Amendments to the 2002 Water System Standards

**BOARD OF WATER SUPPLY
KA 'OIHANA WAI
CITY AND COUNTY OF HONOLULU**

Subject: Your Letter Dated September 15, 2025, Regarding Mueller Company Service Brass Products to Replace Approved James Jones Service Brass Products

DIVISION 400 – APPROVED MATERIALS LIST AND STANDARD DETAILS, Section
403 – Standard Details:

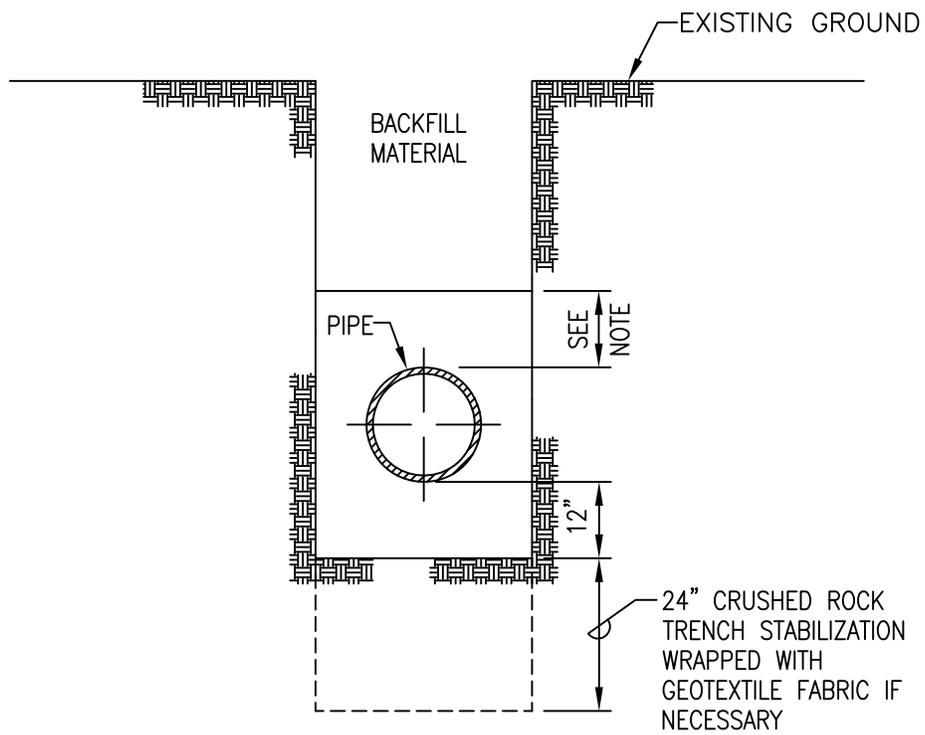
1. Delete Standard Detail P10 TRENCH BACKFILL and replace with the enclosed Standard Detail P10 TRENCH BACKFILL (2016 Revision) which reflects the increase in cushion material below the pipe to 12 inches.

2009
REVISION
M34

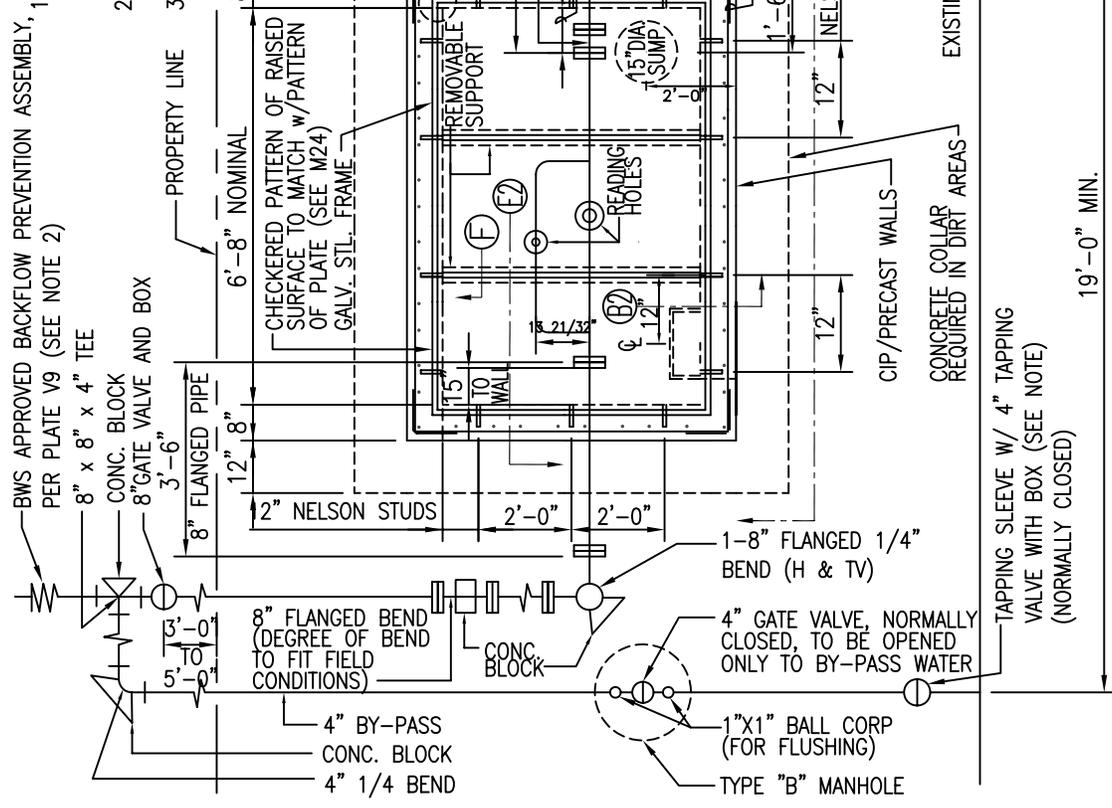
- NOTE: COMBINE MAIN BYPASS TAP WITH 8-INCH LATERAL IF TAPPING TRANSMISSION MAIN OR IF LONG LATERAL RUNS ACROSS A WIDE STREET, A LARGER SIZE LATERAL MAYBE REQUIRED.
- BACKFLOW PREVENTION ASSEMBLY TYPE TO BE DETERMINED BY BWS, IF REQUIRED
 - OUTLET GATE VALVE MUST REMAIN

NOTE:
MAY OMIT ONE VALVE ON
BY-PASS LINE WHEN CONNECTING
TO NEW MAIN
